**From:** [David Cox](#)  
**To:** [Rob Pridham](#); [Johansson, KJ](#); [A303 Stonehenge](#)  
**Cc:** [Natasha Kopala](#); [Parody, Derek](#); [David Bullock](#)  
**Subject:** A303 Amesbury to Berwick Down (Stonehenge) - Response to Secretary of State letter dated 20 August 2020  
**Date:** 28 September 2020 23:11:08  
**Attachments:** [20-09-28 SoS Request for Final Comments 20-08-20.pdf](#)  
[Overarching Summary of Responses to Submissions received by the Secretary of State on 13 August 2020 CLEAN.pdf](#)  
[Detailed Response Tables to Submissions received by the Secretary of State on 13 August 2020 CLEAN.pdf](#)

**Application by Highways England for an Order granting Development Consent for the construction of a new two-lane dual carriage way for the A303 between Amesbury and Berwick Down in Wiltshire**

**Response to request for final comments on representations received in response to the secretary of state's consultation letter dated 16 July 2020**

**Overarching Summary of Responses to Submissions  
received by the Secretary of State on 13 August**

Figure 1. STRAVA Heat Map showing cycle-only activities at Stonehenge and the wider surrounding area

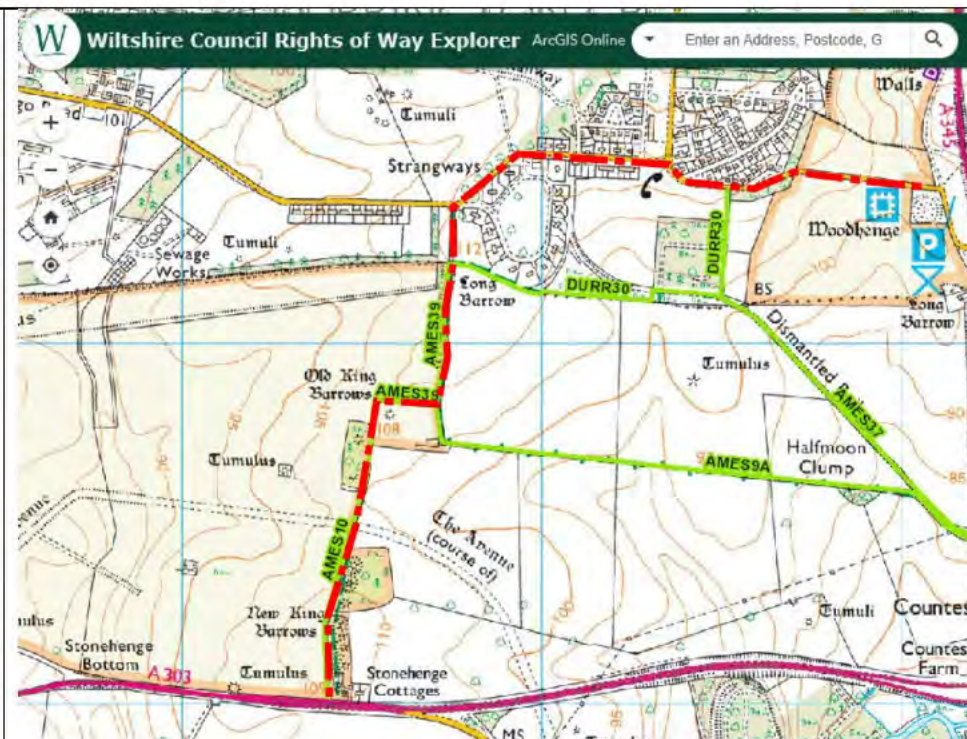
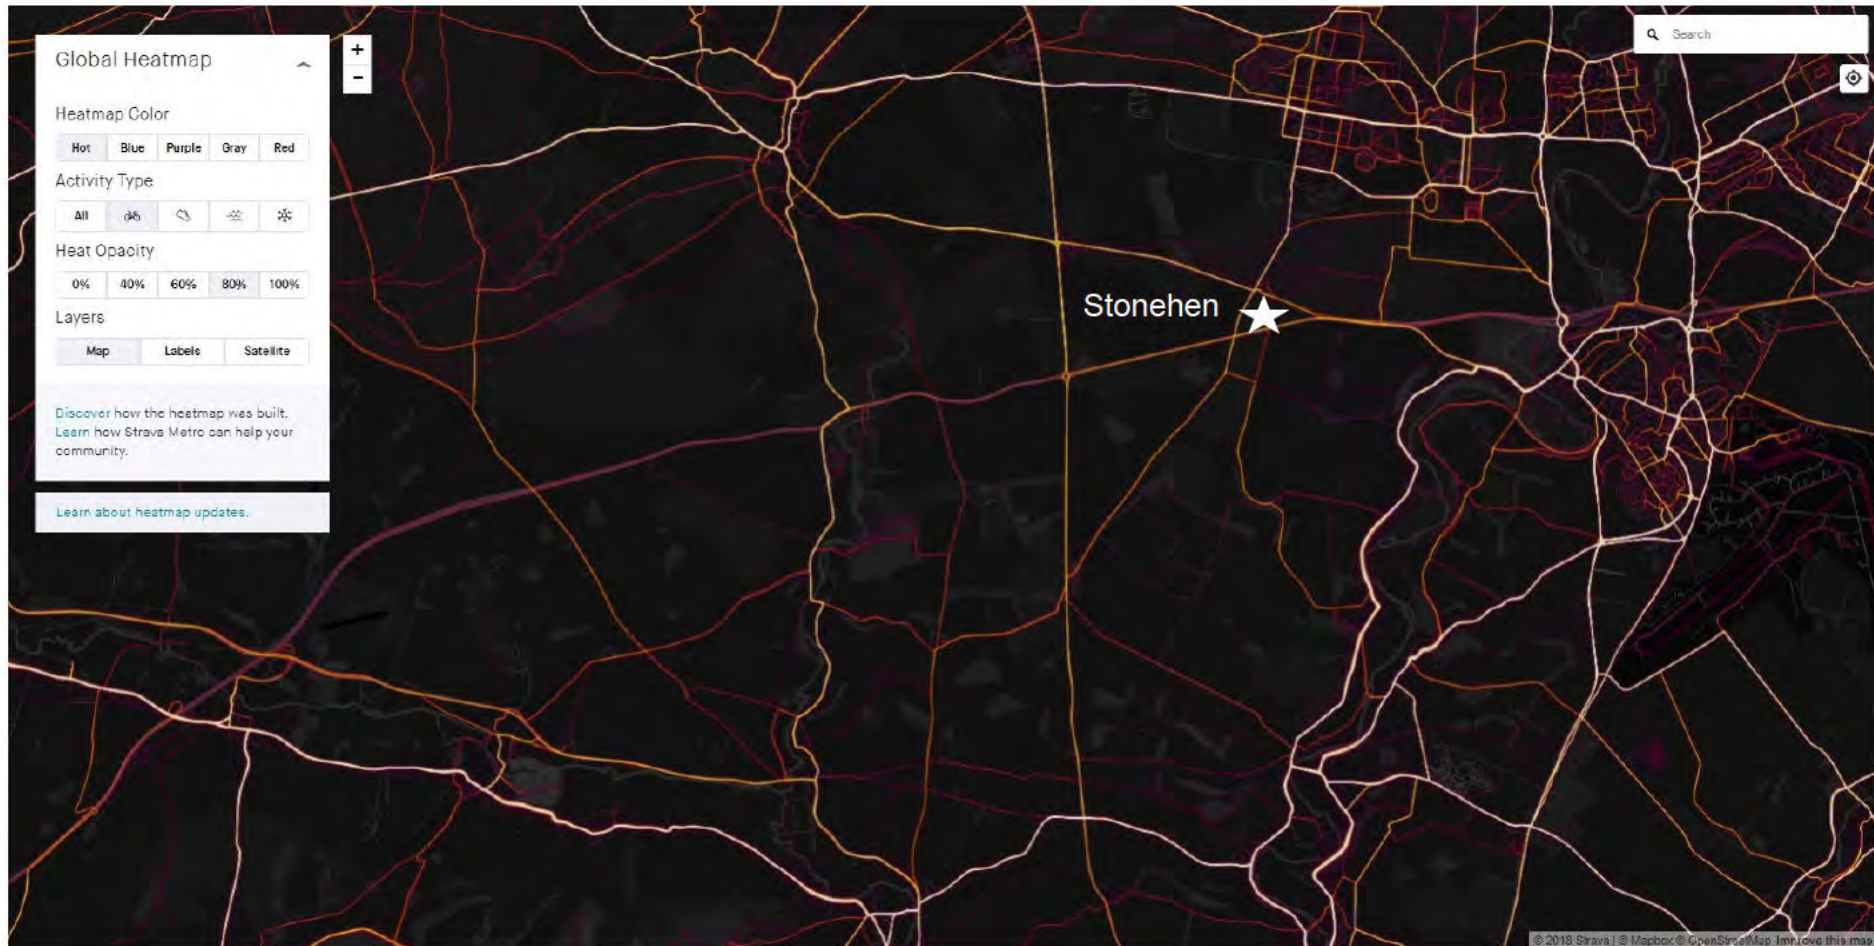
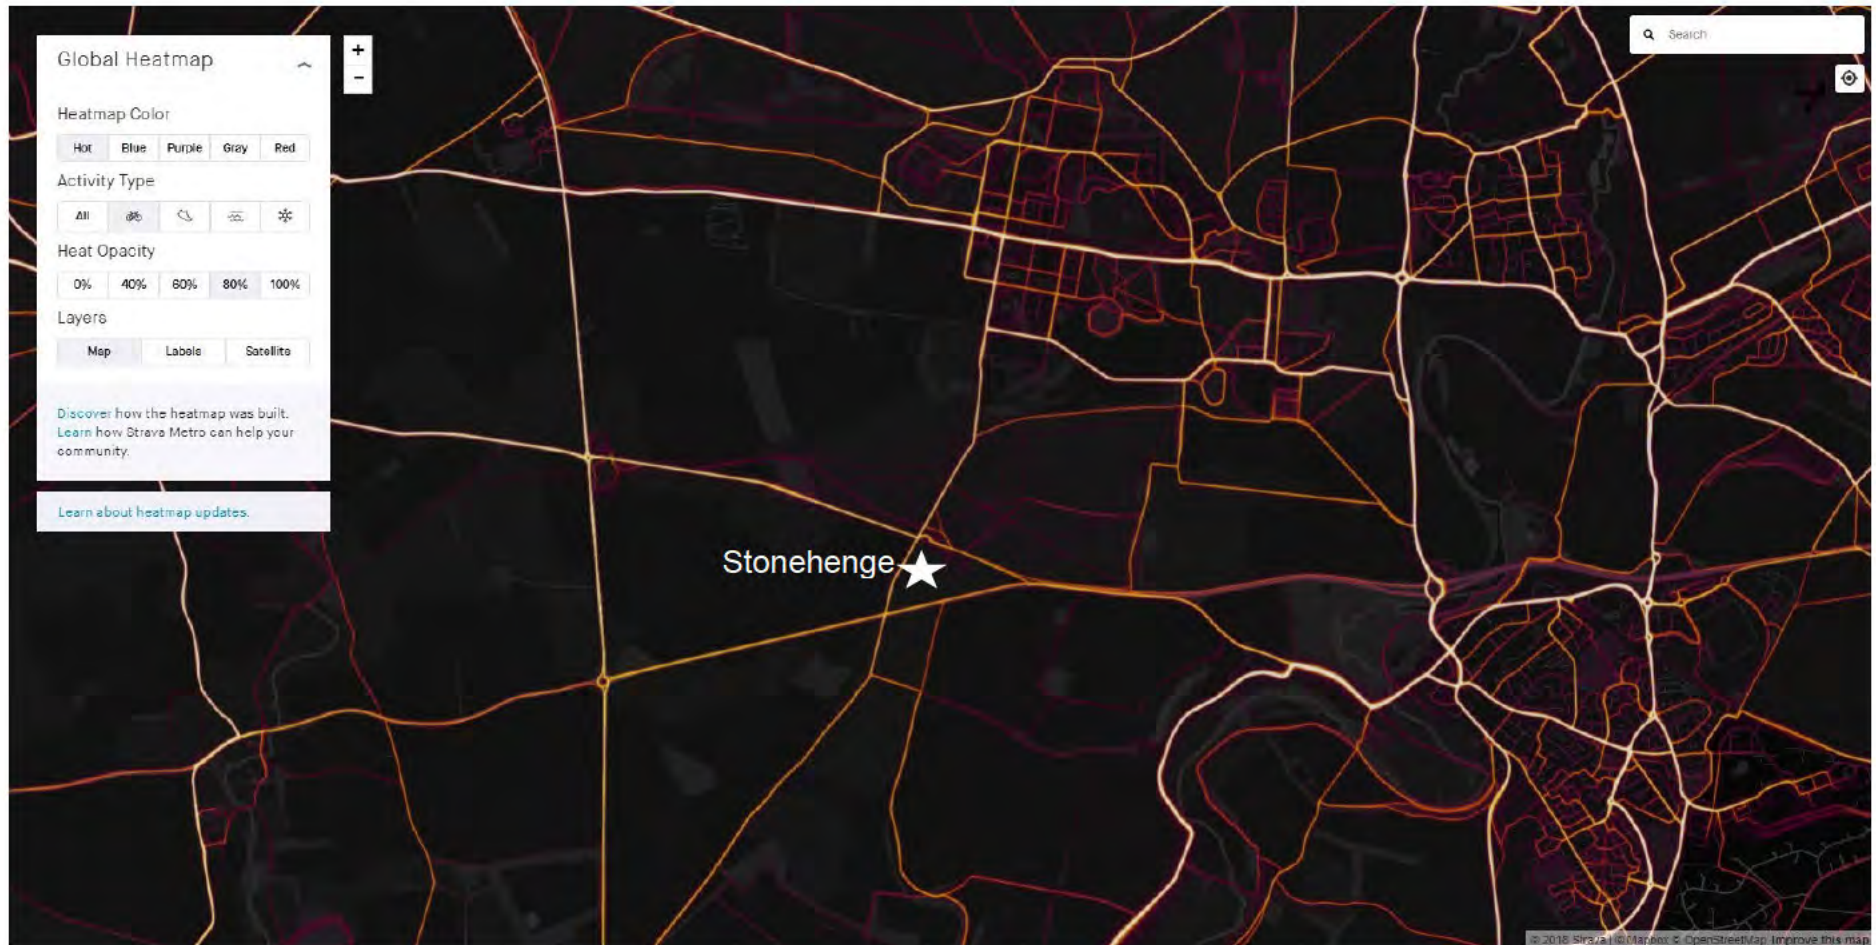
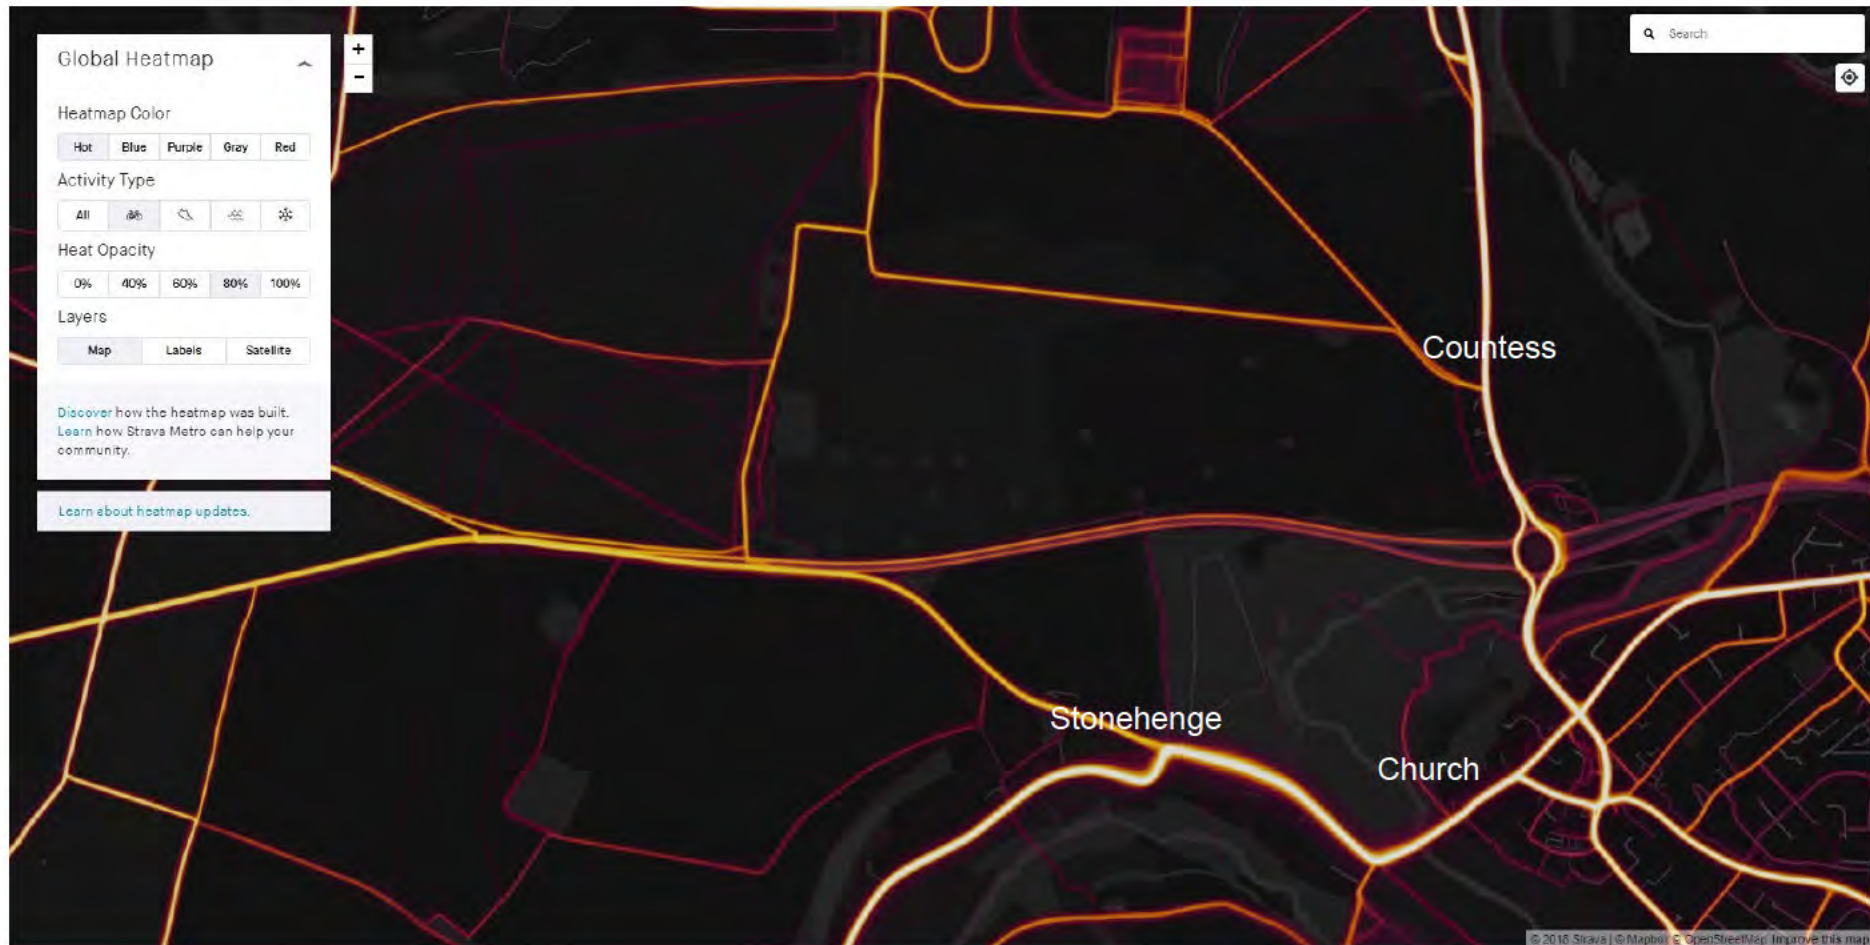
In both Figures 1 and 2, the heat traces illustrate clear use of particular routes and the following observations about the route choices of users can be made:

- The A303 corridor appears dark, indicating lower use by cyclists; other routes show greater 'heat,' suggesting alternative routes are significantly favoured by cyclists;
- The Packway (Larkhill) - Tidworth Road link is a dominant east-west route north of the A303 and Stonehenge;
- The A36 and Church Bottom is a dominant east-west route south of the A303 and Stonehenge.
- Use of the two unclassified roads south of Amesbury, to the west of the A345, for north-south movements;
- The staggered movements across the A303 can be determined between Stonehenge Road and the permissive route immediately north of the Stonehenge site (Figures 2 and 3). This movement requires users to travel along the A303 for a short distance and cross oncoming traffic. The traces are brighter on the southern side of the A303, suggesting use of the pavement adjacent to the carriageway at this location.

Figure 3 illustrates use of Stonehenge Road, Church Street and Countess Road by cyclists, with the white heat in marked contrast to the A303. The use of minor road and off-road route north of the A303 linking the Stonehenge site with Countess Road suggests cyclists are actively avoiding using the A303.

<p>3.30</p>	<p>The alternative route for cyclists, via Stonehenge Road and Amesbury town centre, is unsuitable in its conditions and its location. It uses roads such as London Road, where cycling conditions are so poor the Sustrans left a gap in National Cycle Route 45 rather than endorse the use of this road. A cycle journey from Stonehenge Bottom to Woodhenge would take an estimated 36 minutes via Church Street, instead of 13 minutes via A303 (source: Google Maps).</p>	<p>The Scheme will provide an extensive network of routes available to cyclists including 10 miles of surfaced restricted byways and bridleways from which motor vehicles are excluded. This network includes a good alternative route to the tunnel for cyclists along the existing A303 with connections to Amesbury via National Cycle Network Route 45 and a new bridleway to Winterbourne Stoke.</p> <p>Sustrans' map of the National Cycle Network indicates National Cycle Route 45 as an on-road route between the Stonehenge Road / Woodford Road junction and B&amp;M Homestore on London Road, at which point the off-road route continues in an easterly direction towards Bulford via the Solstice Park junction</p>

In conclusion, and for the detailed reasons set out above, Highways England does not intend the proposed A303 tunnel to be used by cyclists. Moreover, Highways England considers that the (late) representation submitted by Cycling UK does not present any sound or compelling reasons for Highways England to change that intention or to change the Scheme for which Development Consent is now sought.
